### CONSOLIDATED PERMIT FOR DESIGN REVIEW AND CRITICAL AREAS

**DR2023-0008/CAP2023-0008/SEP2023-0008**  
**1204 YEW STREET-WELLINGTON PRELIMINARY PLAT**  
**Type I**

#### I. SUMMARY OF DECISION

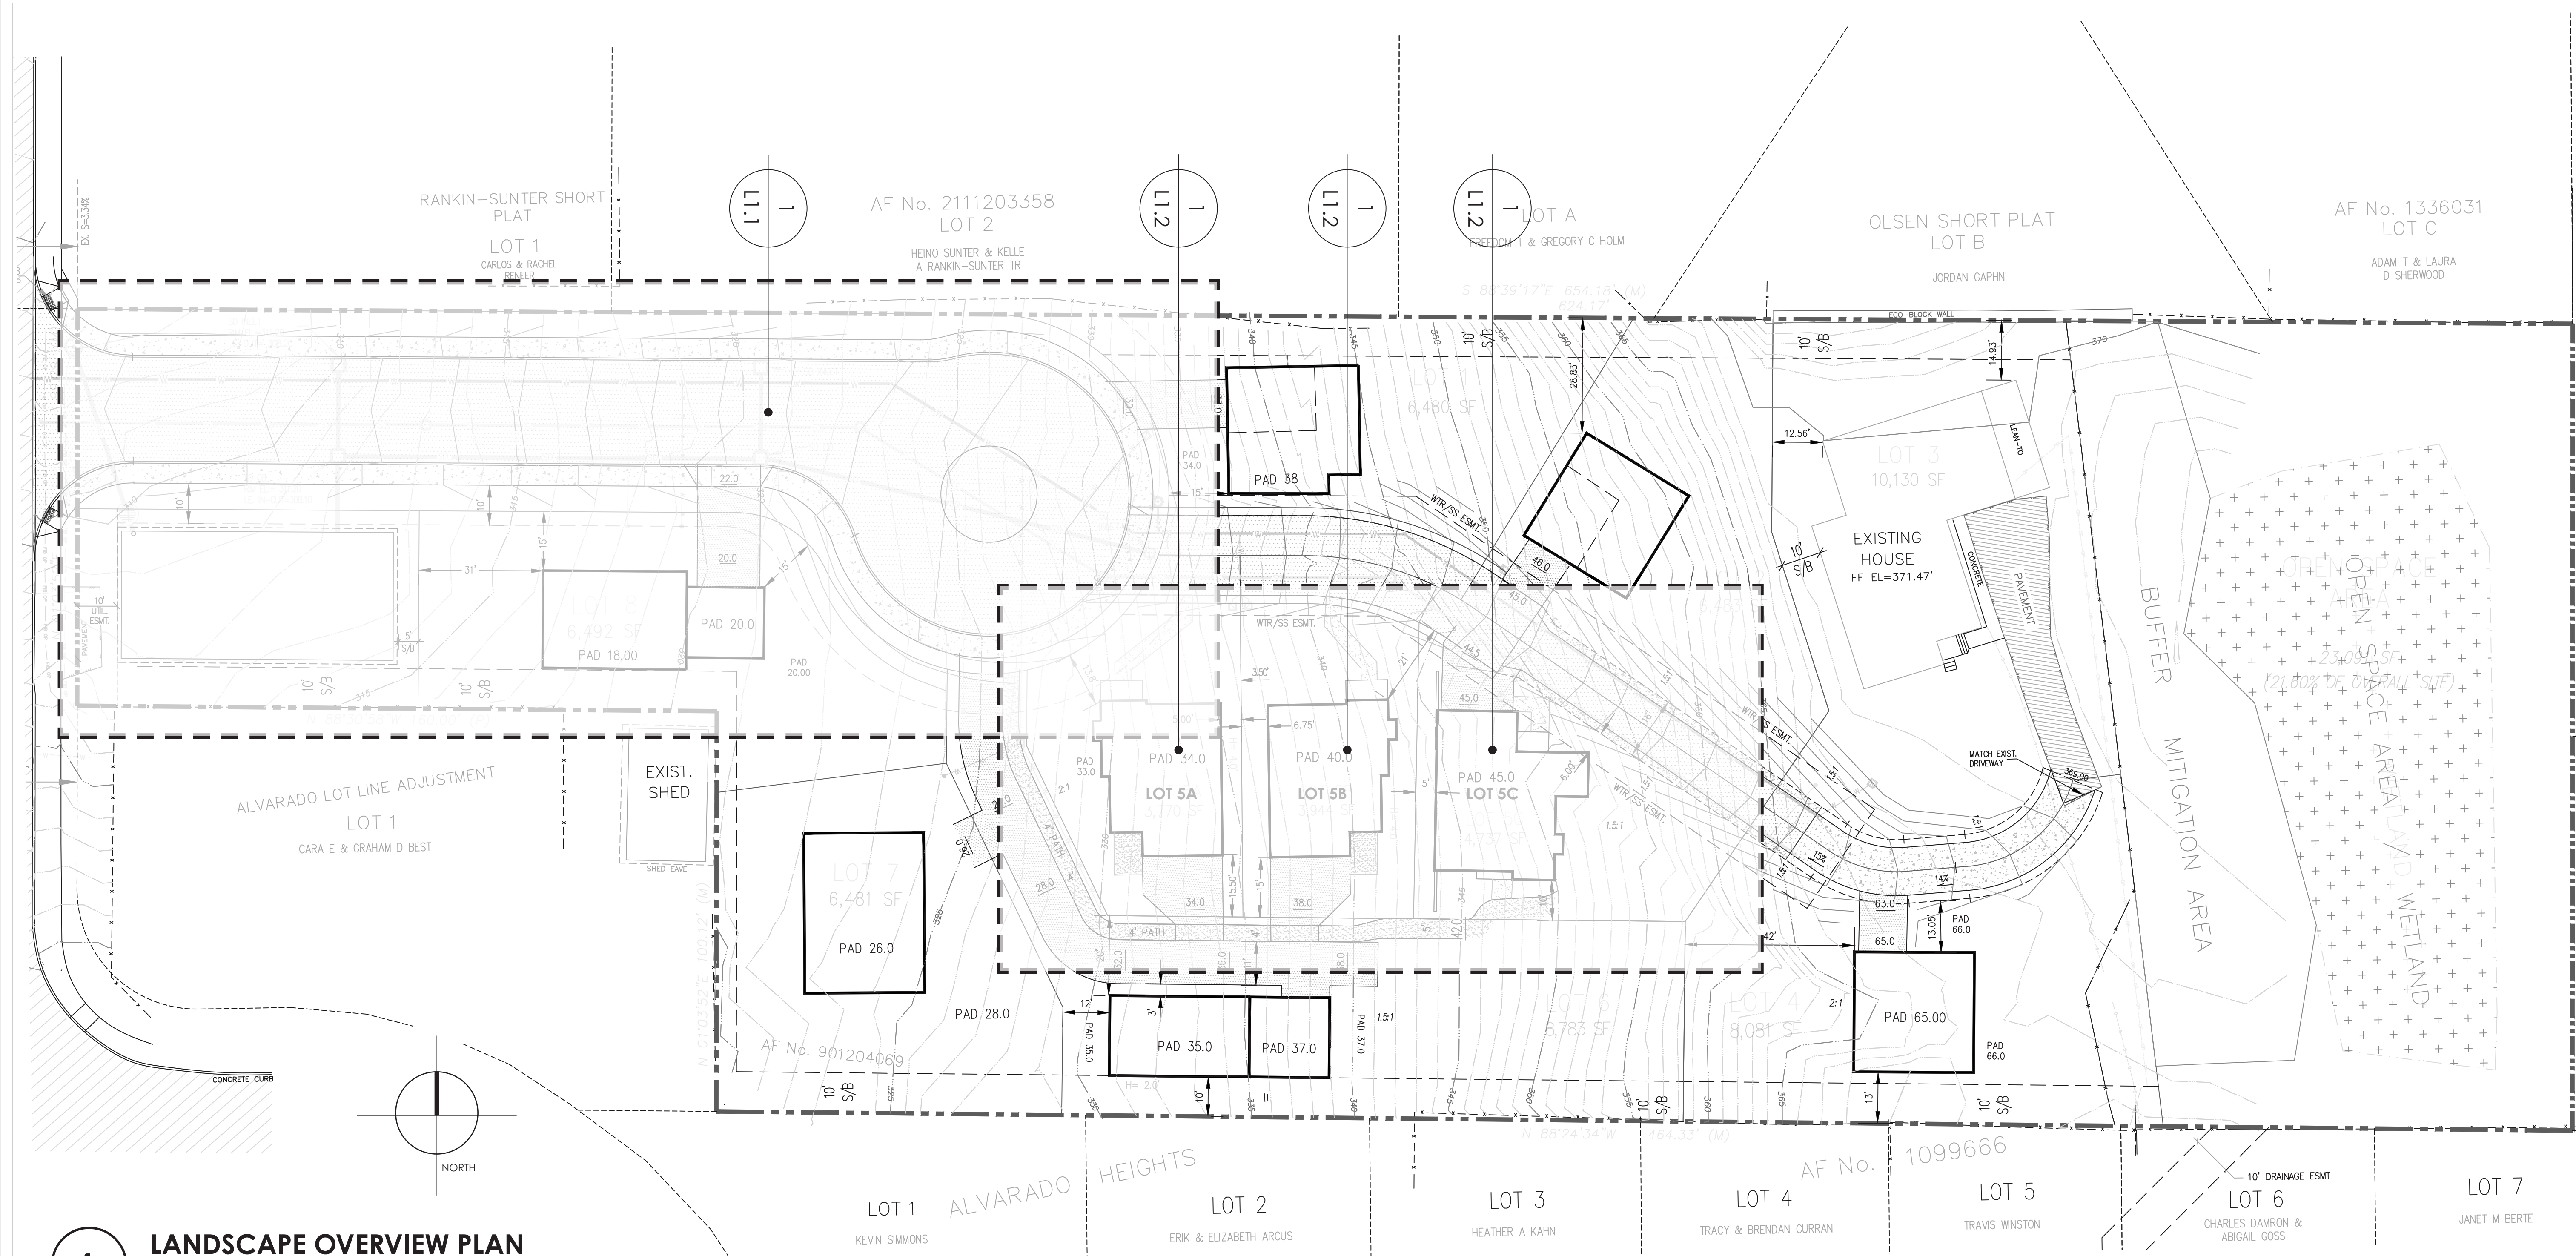
*INFORMATIONAL: Additional review comments are provided on the attached Sheet 4 of 5 of the preliminary engineering plans. Many of these comments are more appropriately addressed when construction plans are submitted for review by the City. However, the City is providing review comments at this time to ensure compliance with any of these comments will not result in additional plat design revisions.*

*Private driveways serving more than 2 lots must be designed pursuant to Figure 23.08.060(A). The northern driveway does not meet this design provision.*
